ATTACHMENT 3
TECHNICAL SPECIFICATION MARK-UP
and
Revised Figure 3.4.11-1

**Structural Integrity Associates, Inc. Letter Report
Revised (12 EFPY) P-T Curves for River Bend Station
Letter #GLS-96-059; SIR-96-096, Rev. 0
October 22, 1996**

Subject: Revised (12 EFPY) P-T Curves for River Bend Station

Figure 1. P-T Curves for 12 EFPY

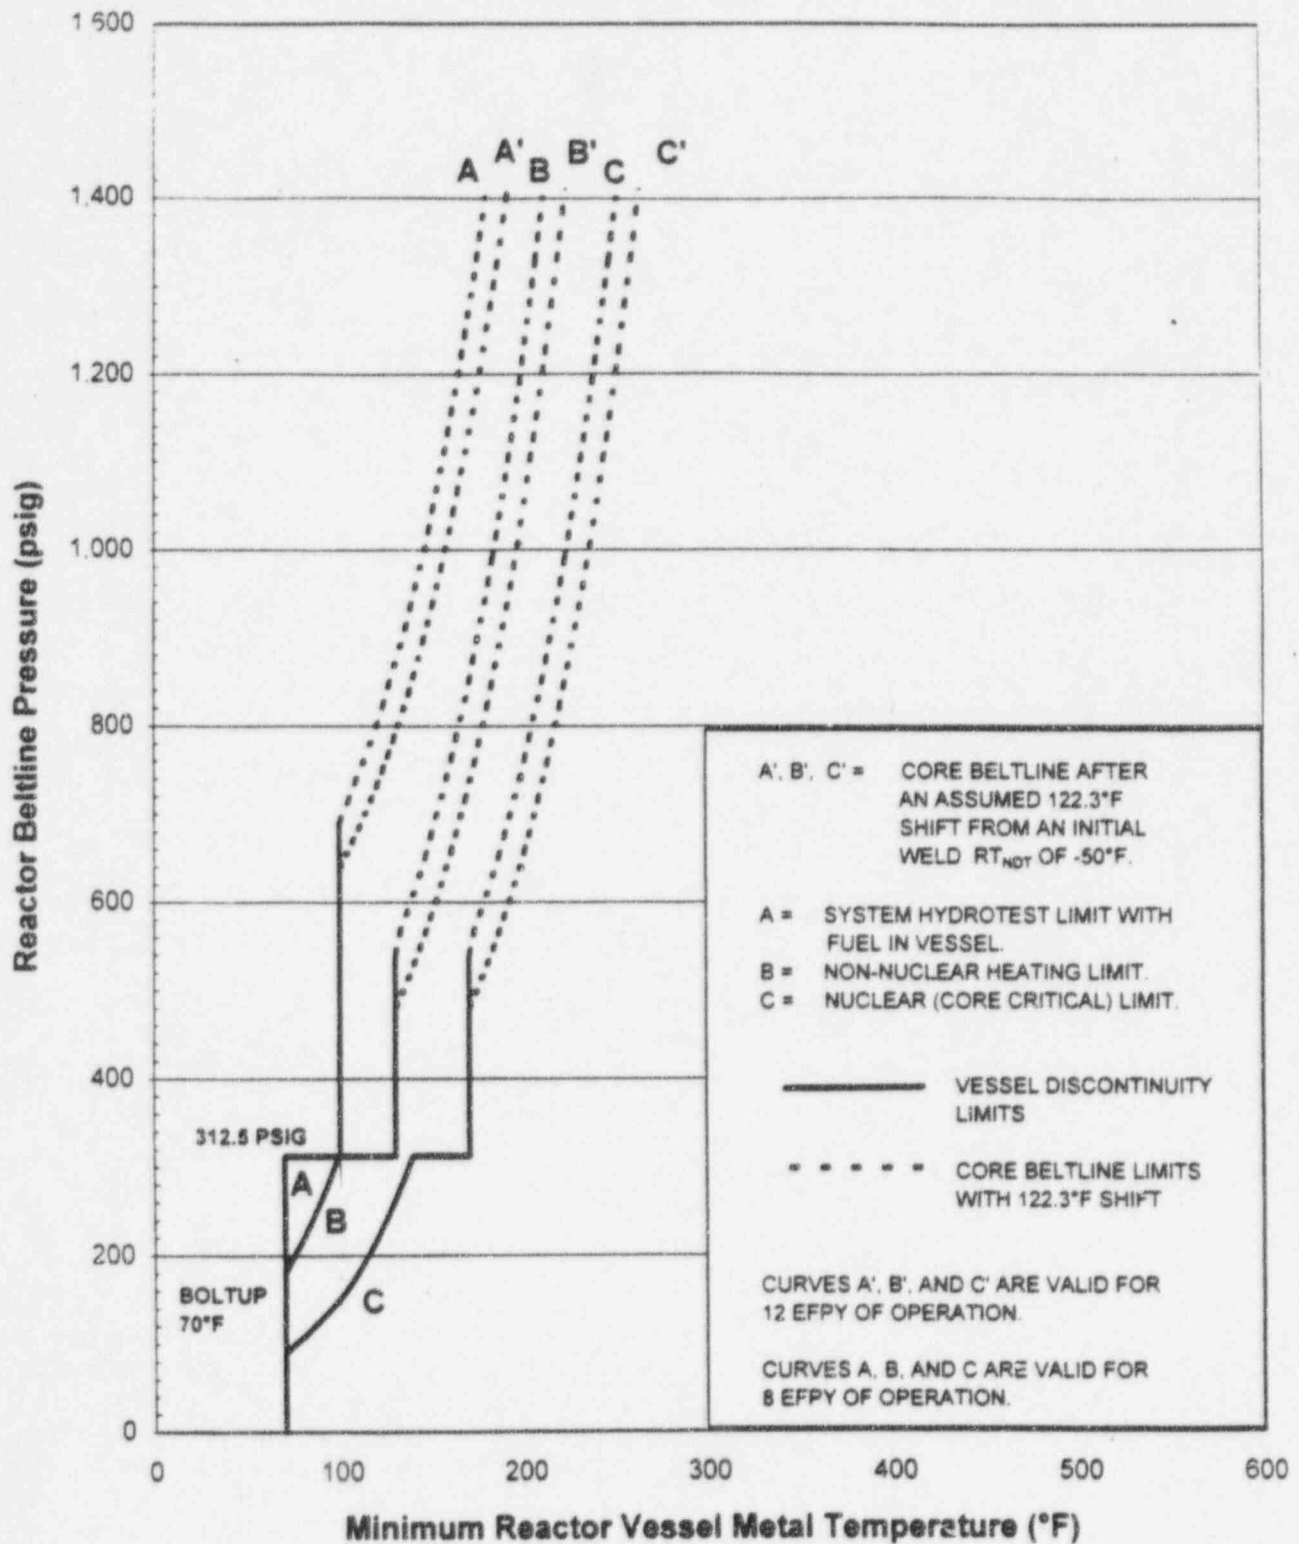
The P-T curve EXCEL spreadsheet was next used to generate the 12 EFPY P-T curves. The limiting ART value used comes from Table 1 for 12 EFPY, and is 72.3°F. This value was entered into the spreadsheet to generate the 12 EFPY P-T curves. The results are shown in Table 2 and Figure 1. Also contained within this table and figure are the current 8 EFPY Tech. Spec. curves [2,5] for comparative purposes.

Finally, Table 2 and Figure 1 provide the results of the P-T curve spreadsheet for 12 EFPY. The results are seen to be reasonable based on the "shift" in results from those at 8 EFPY. This, coupled with the results of the "benchmark" test case, conclude the Figure 1 P-T limits to be appropriate for RBS for 12 EFPY of operation.
